ARKANSAS POWER & LIGHT COMPANY
POST OFFICE BOX 551 LITTLE ROCK, ARKANSAS 72203 (501) 371-4000
August 31, 1979

Subject: Arkansas Nuclear One-Unit 1
Docket No. 50-313
License No. DPR-5,
IE Bulletin 79-14
(File: 2-1510)

IE 79-14 WALKDOWN SUMMARY

SECTION A-A

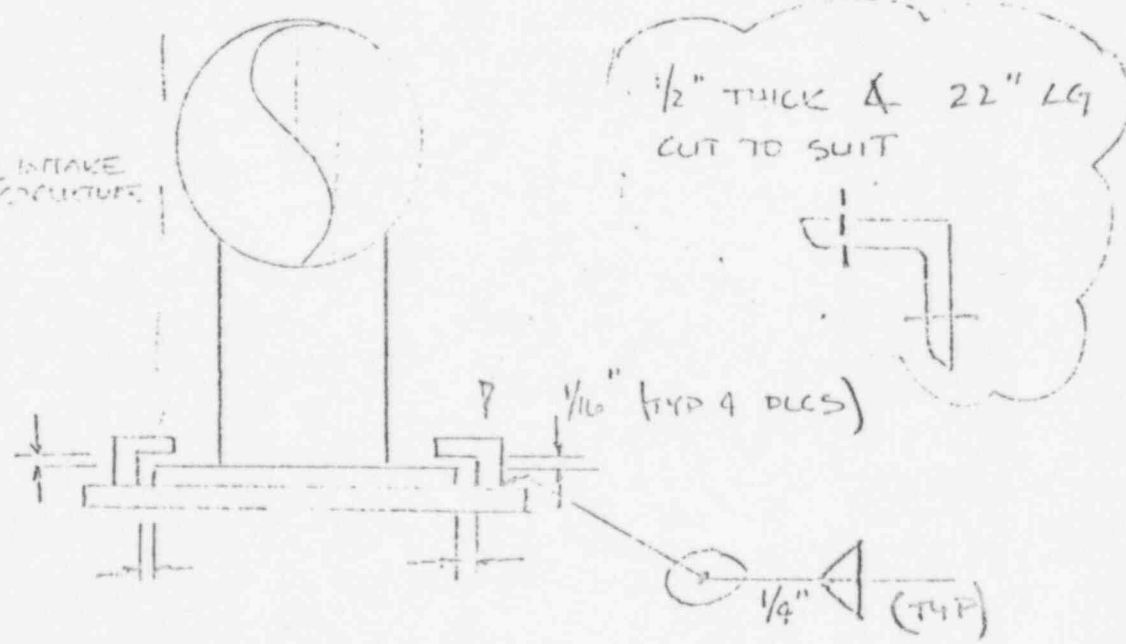
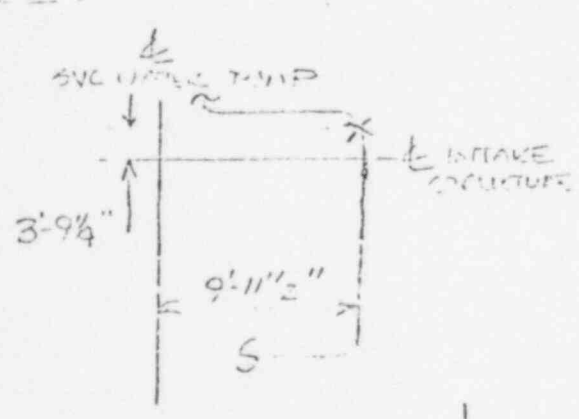
ADD ANGLES TO PROVIDE LATERAL & VERTICAL RESTRAINT
